Wichita-Sedgwick County Metropolitan Area Planning Department

April 5, 2016

RE: BZA2016-00014: City Sign Code Adjustment to increase the height of an existing on-site pole sign from 35 to 38 feet, in LC Limited Commercial zoning.

D/S Illuminated Pylon Box
Scale: N.T.S

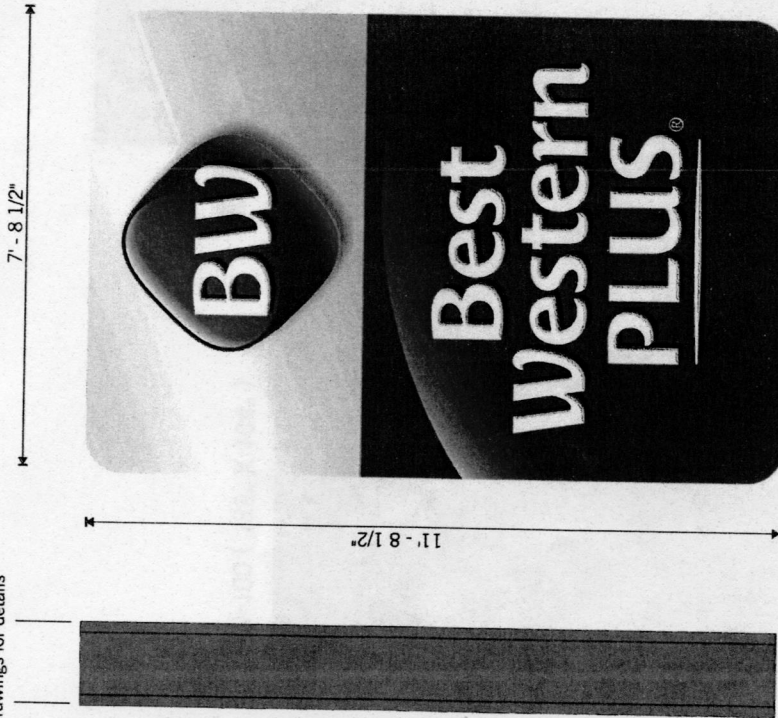
We have reviewed your request for a Sign Code Adjustment to increase the height of an existing on-site pole sign by up to 20% in LC zoning. Total square feet of signage is 107 square feet per side.

We find that allowing the height adjustment of the existing on-site pole sign as proposed meets the three conditions required by Section 24.04.251.6 of the Sign Code as set out below:

Our signatures below indicate that a Sign Code Adjustment to increase the height of an existing on-site pole sign by up to 20%, from 35 to 38 feet, in LC-Limited Commercial zoning on the aforementioned property is hereby granted, subject to the following conditions:

- 1) The Sign Code Adjustment is for an increase in height from 35 feet to 38 feet only; all signage on the site shall otherwise conform to the Sign Code unless a separate adjustment or variance is approved. No additional signage will be allowed on the site as the maximum permitted signage has been reached.
- 2) The sign shall be in conformance with the approved elevation and site plan. The sign shall be permitted and installed within one year from the date of approval. Portable signs are not allowed on the site.
- 3) If the Zoning Administrator finds that there is a violation of any of the conditions of the Sign Code Adjustment, the Zoning Administrator, in addition to enforcing the other remedies set forth in the Sign Code, may, with the concurrence of the Planning Director, declare that the Sign Code Adjustment is null and void.
